Access Compliance Report

Public Rights-of-Way

(Curb Ramps)

Intersection ID: 50927	Main Street: LANDING_PLACE_LN	Cross Street: LANCASTER_HY	Location: W
ADA ID: 0A2E16D6AE12	Ramp Type: PerpDiag	Initial Pass/Fail: Fail	Overall Compliance: No
		Severity Score: 12.5

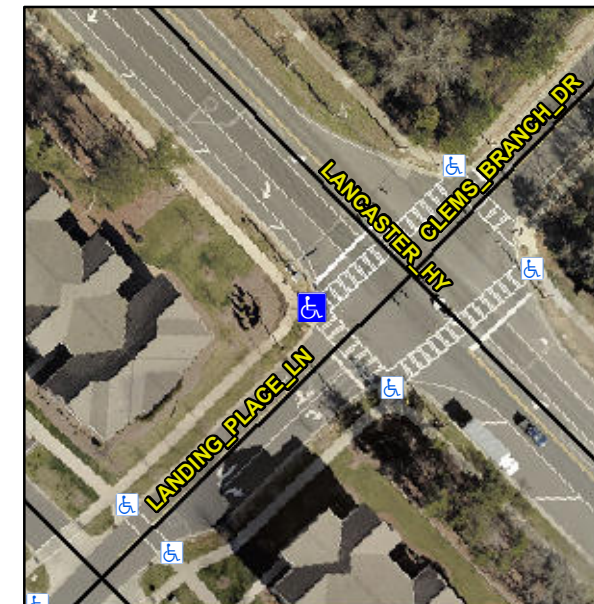
Not Found, R304.5.3

Compliance	Description	Data	Compliance	Description	Data
N/A	Ramp Length (in)	94.0	Yes	Ramp Slope (%)	6.2
Yes	Ramp Width (in)	60.0	No	Ramp XSlope (%)	5.9
N/A	Flare Type LT	N/A	N/A	Flare Type RT	N/A
N/A	Flare Slope LT (%)	N/A	N/A	Flare Slope RT (%)	N/A
N/A	Flare Traversable LT?	N/A	N/A	Flare Traversable RT?	N/A
N/A	Landing Length (in)	N/A	N/A	DWS Provided?	N/A
N/A	Landing Width (in)	N/A	N/A	DWS Contrast?	N/A
N/A	Landing Slope (%)	N/A	N/A	DWS Length (in)	N/A
N/A	Landing X Slope (%)	N/A	N/A	DWS Full Width?	N/A
N/A	Landing Curb? (Y/N)	N/A	N/A	DWS Offset (in)	N/A
N/A	Shared Landing?	N/A			
N/A	Gutter Ponding?	N/A	N/A	Gutter Slope (%)	N/A
N/A	Gutter Lip Ht (in)	N/A	N/A	Gutter X Slope (%)	N/A
N/A	Painted X Walk1?	Yes	N/A	Painted X Walk2?	No
	X Walk 1 Direction	To SE		X Walk 2 Direction	To NE
N/A	X Walk 1 Width (in)	84.0	N/A	X Walk 2 Width (in)	N/A
	X Walk 1 Slope (%)	1.4		X Walk 2 Slope (%)	0.0
	X Walk 1 X Slope (%)	3.3		X Walk 2 X Slope (%)	1.8

Remove & Replace Curb Ramp With Two New Directional Ramps or Equivalent.
